第8回加東市社地域小中一貫校開校準備委員会 【資料1】

基本設計時と実施設計時との比較（R3. 9. 30現在）

R3. 10. 27(水) 19:30～
加東市役所 2階 201会議室

配置計画図

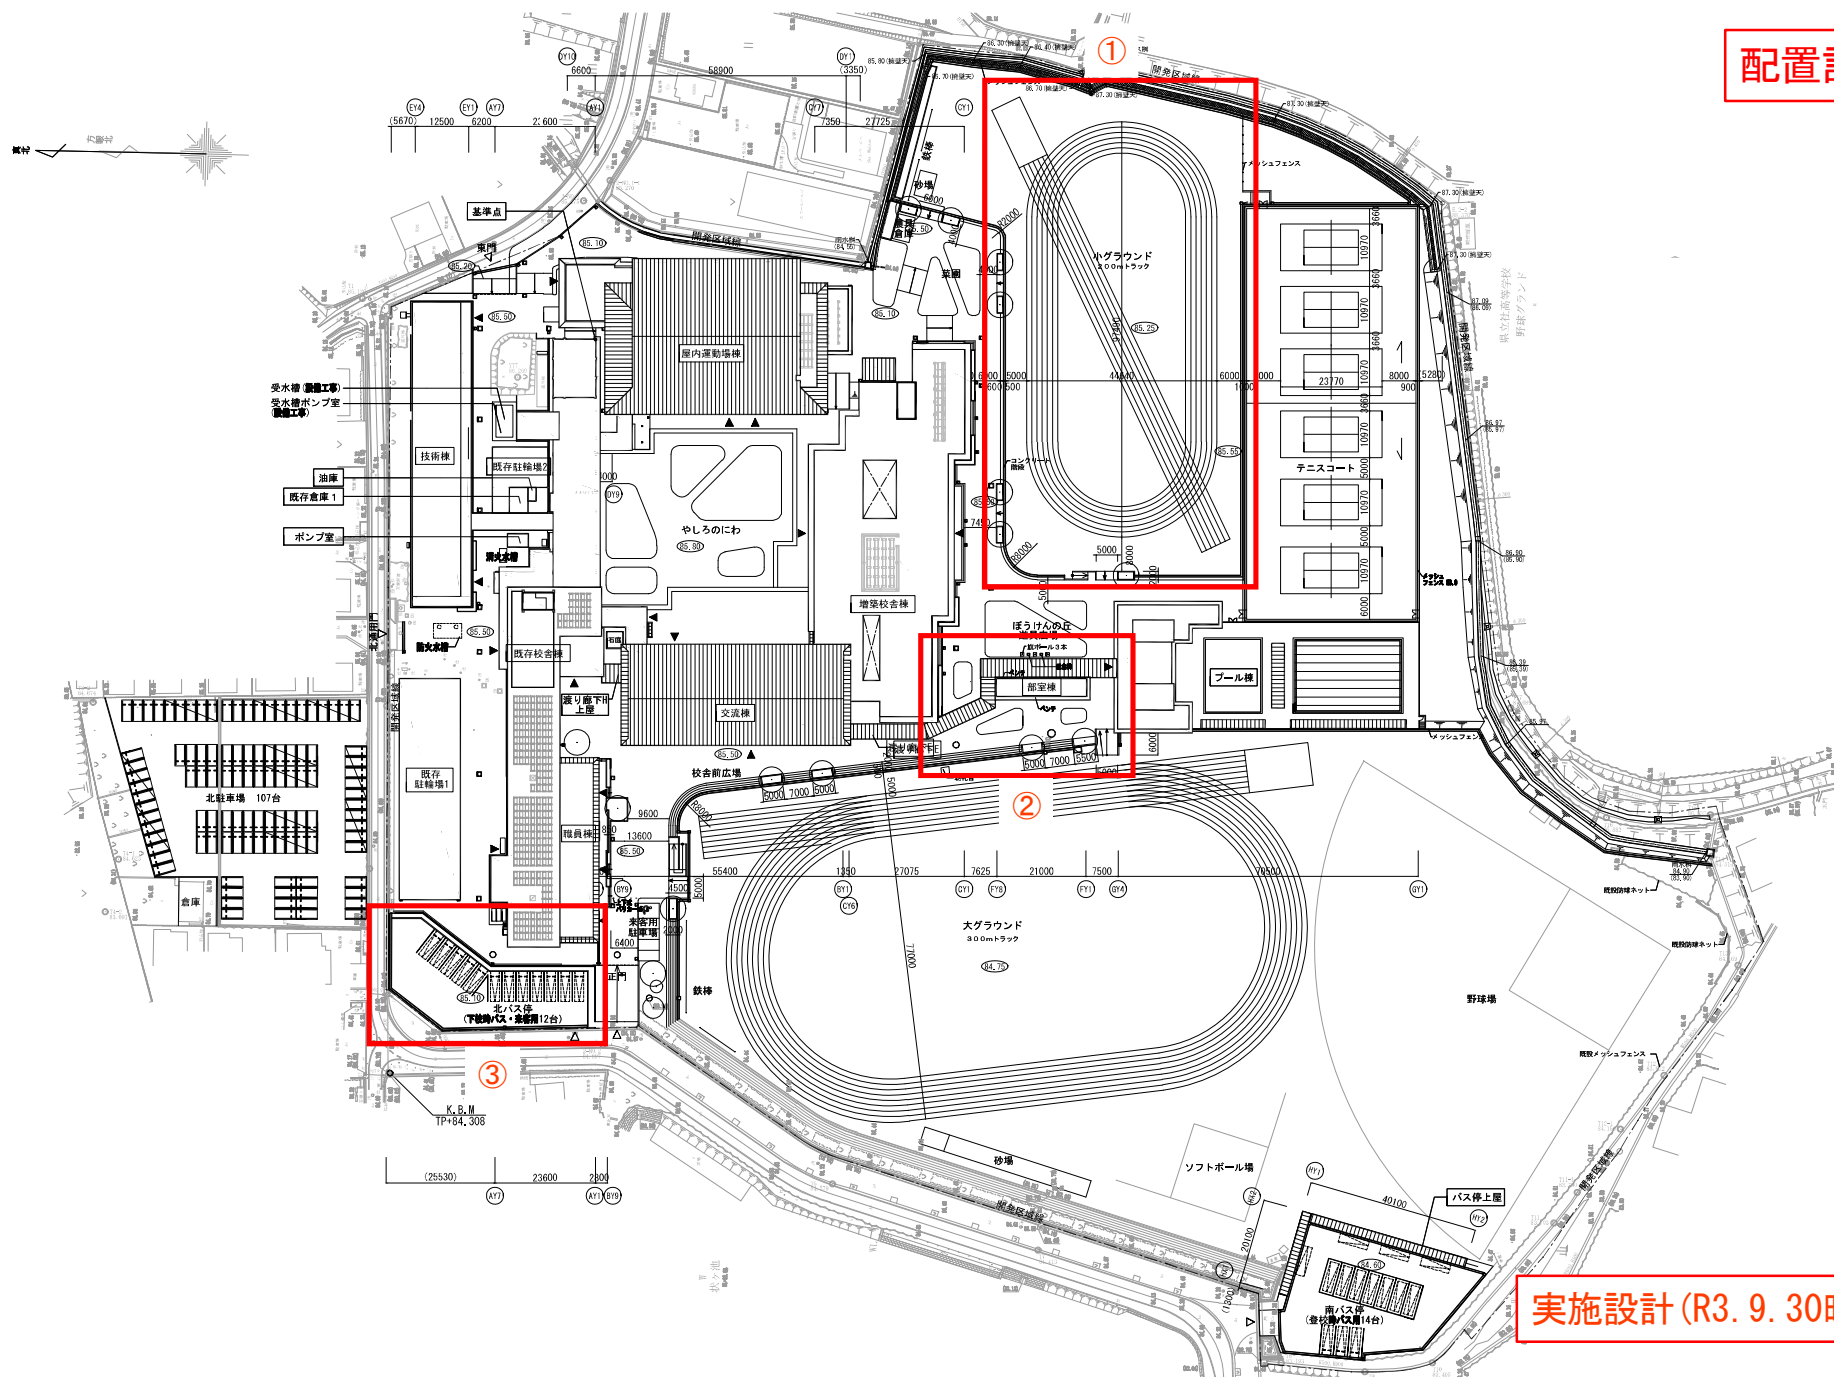
①トラックの向き変更
トラック周りにスペースを確保するため

②部室棟と渡り廊下の形状変更
消防車両の進入ルートを変更したため

③バスの配置変更
スクールバス乗車児童の安全を確保するため

1 階平面図

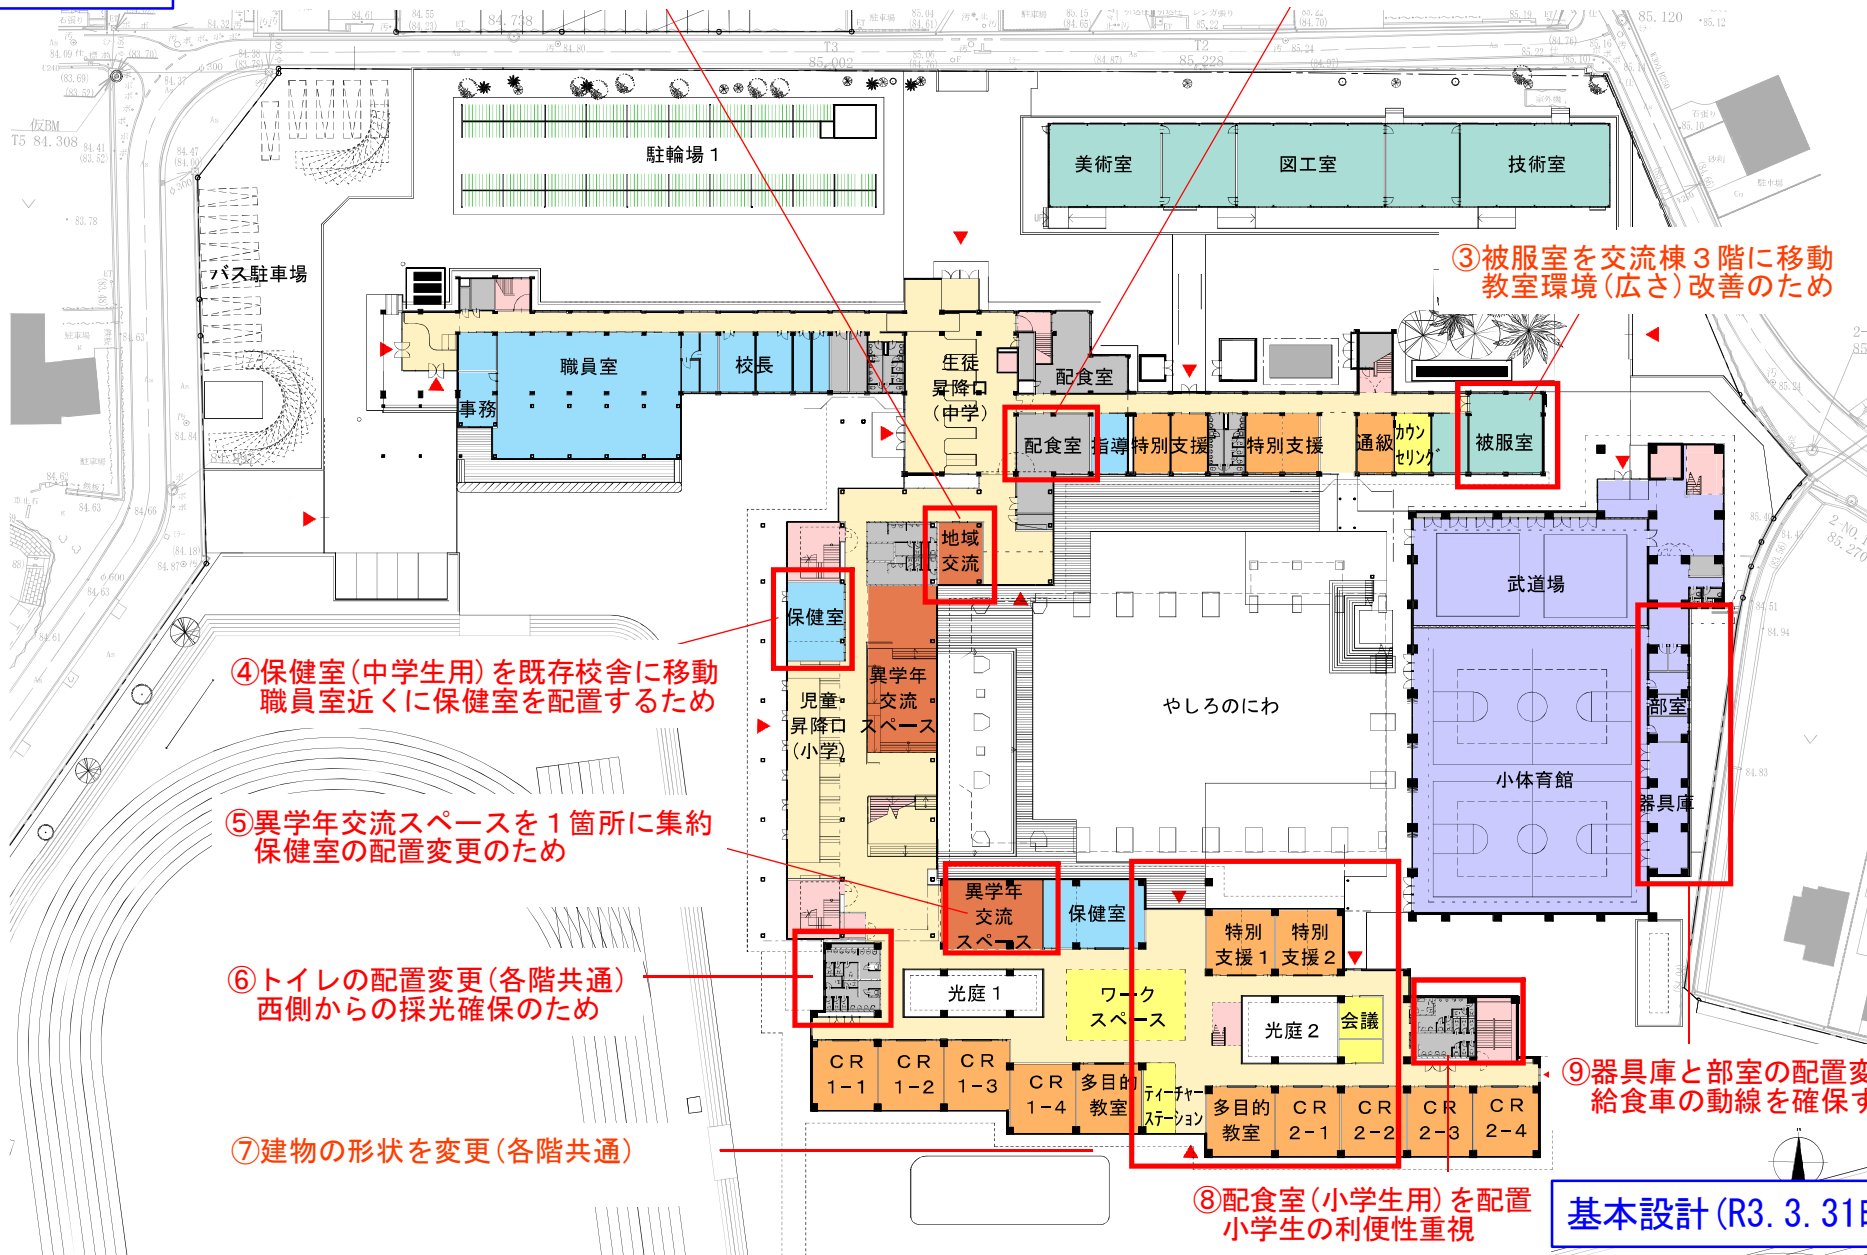
①地域交流室を移動
面積を広げるとともに地域利用がしやすい配置とするため

②配食室(小学生用)を増築校舎へ移動
小学生の運搬距離を短くするため

③被服室を交流棟3階に移動
教室環境(広さ)改善のため

④保健室(中学生用)を既存校舎に移動
職員室近くに保健室を配置するため

⑤異学年交流スペースを1箇所を集約
保健室の配置変更のため

⑥トイレの配置変更(各階共通)
西側からの採光確保のため

⑦建物の形状を変更(各階共通)

⑧配食室(小学生用)を配置
小学生の利便性重視

⑨器具庫と部室の配置変更
給食車の動線を確保するため

2階平面図

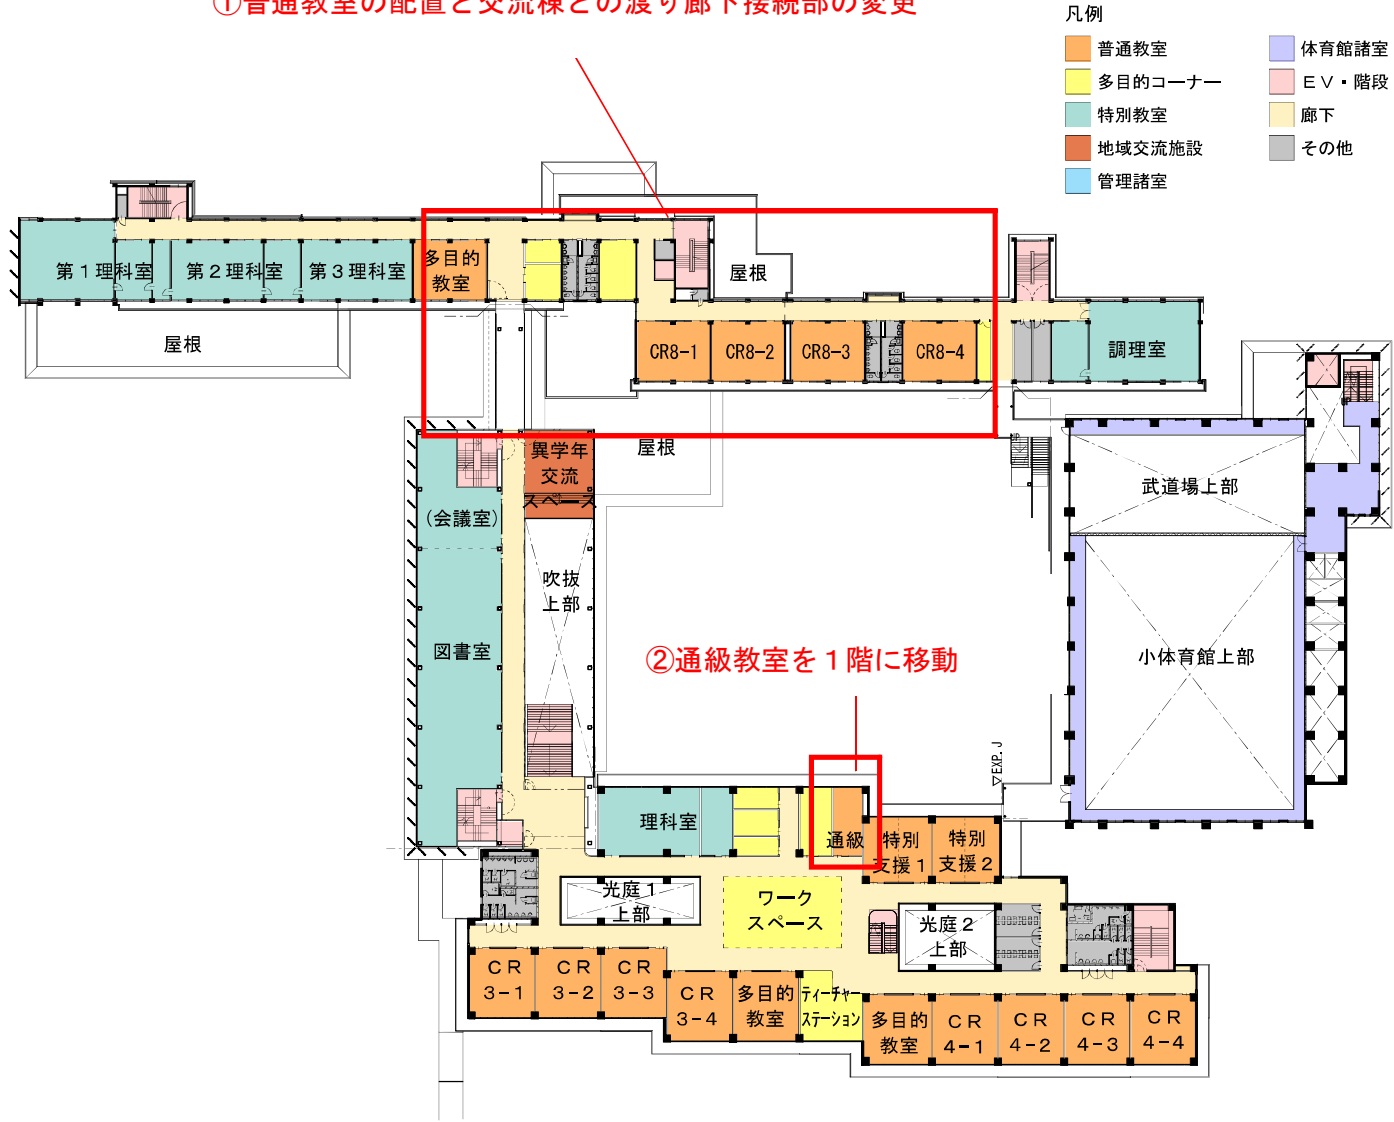
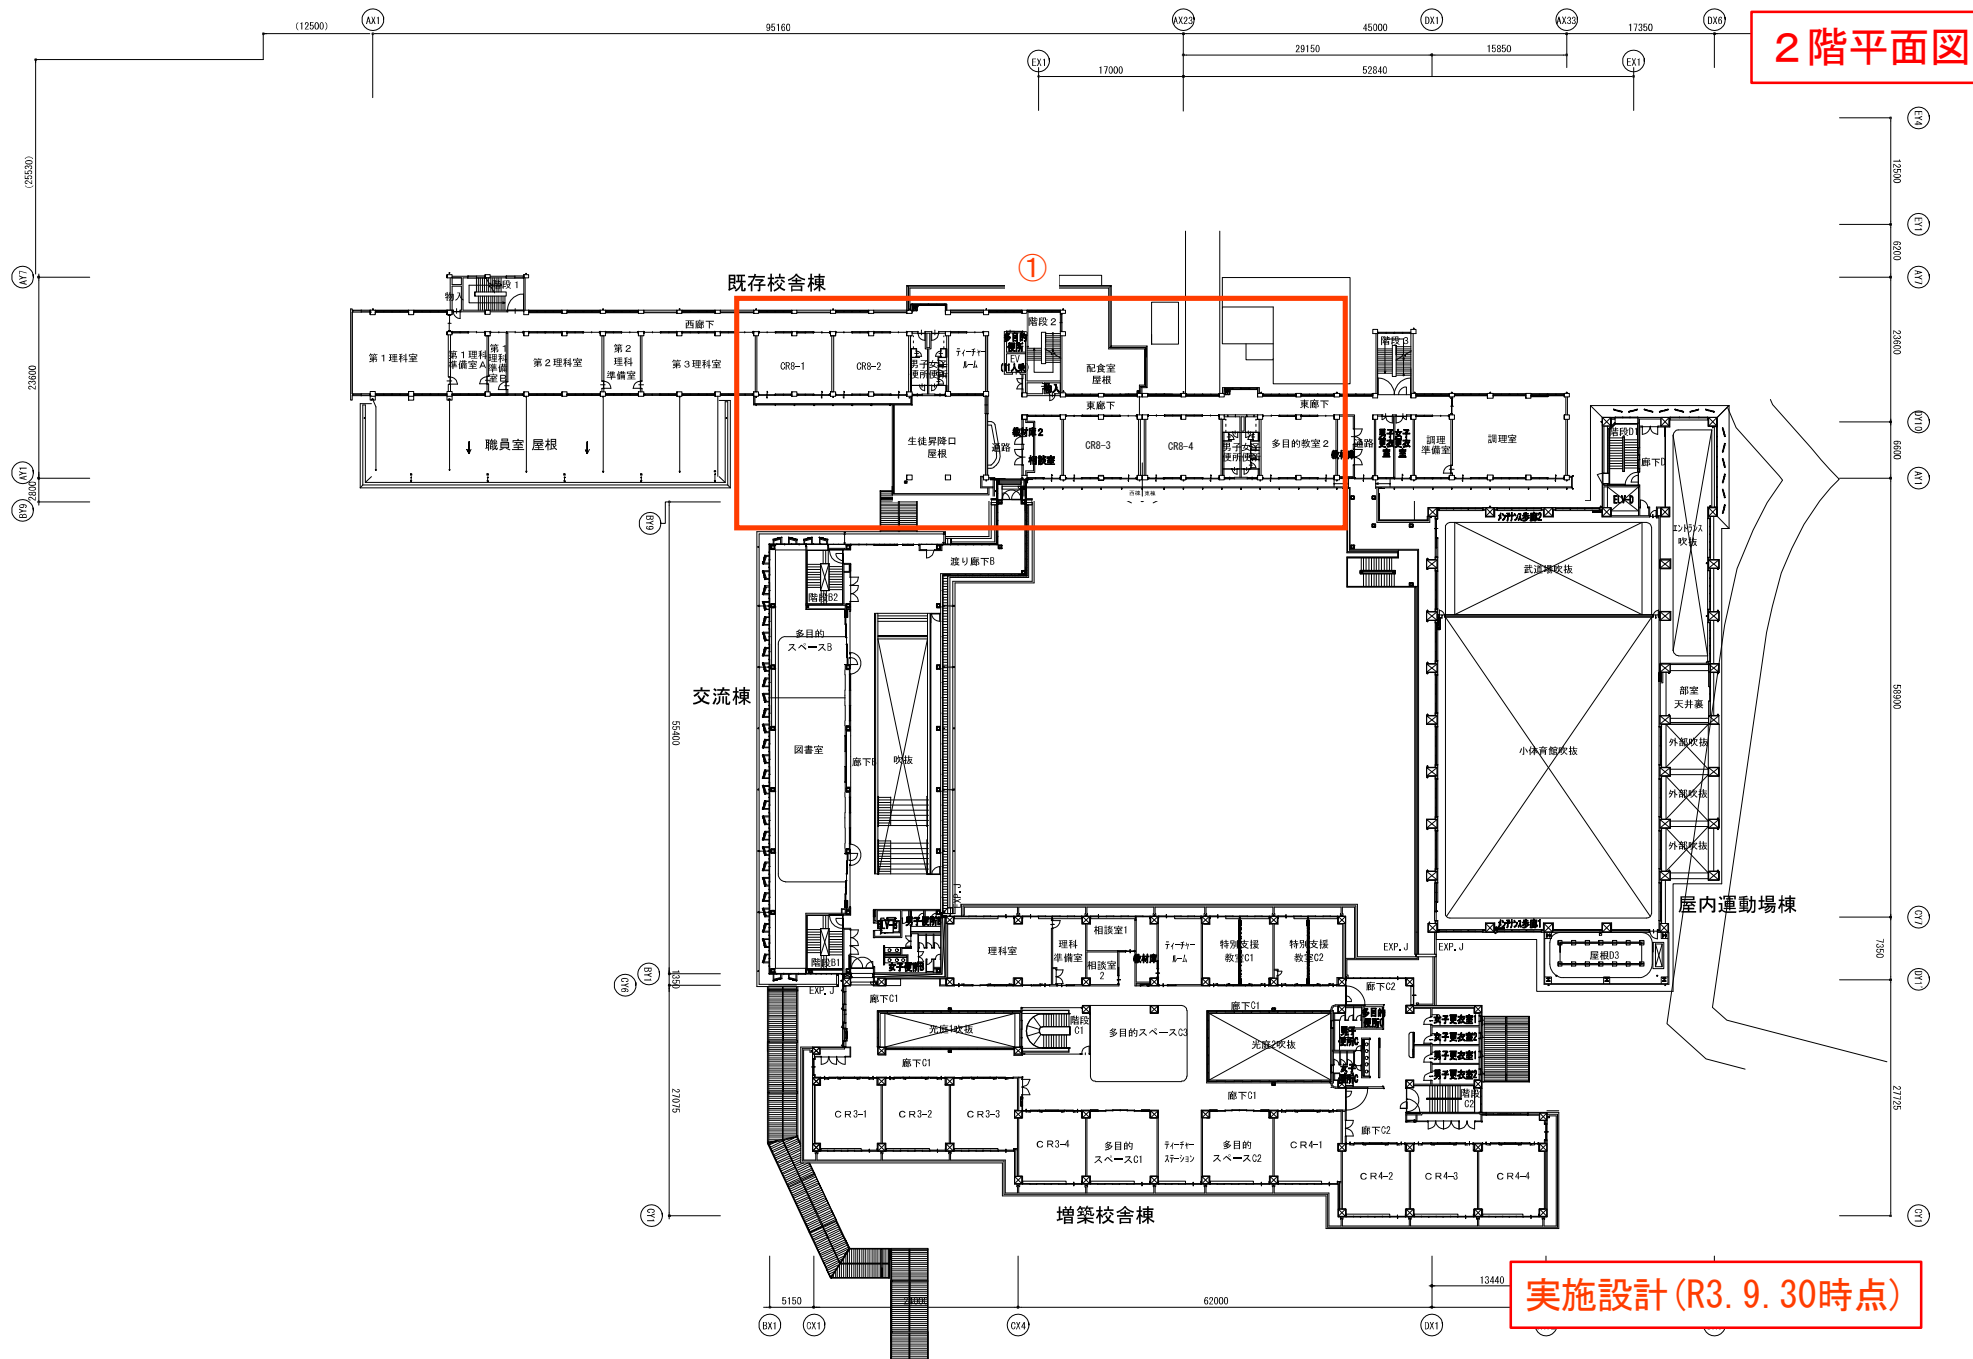
①普通教室の配置と交流棟との渡り廊下接続部の変更
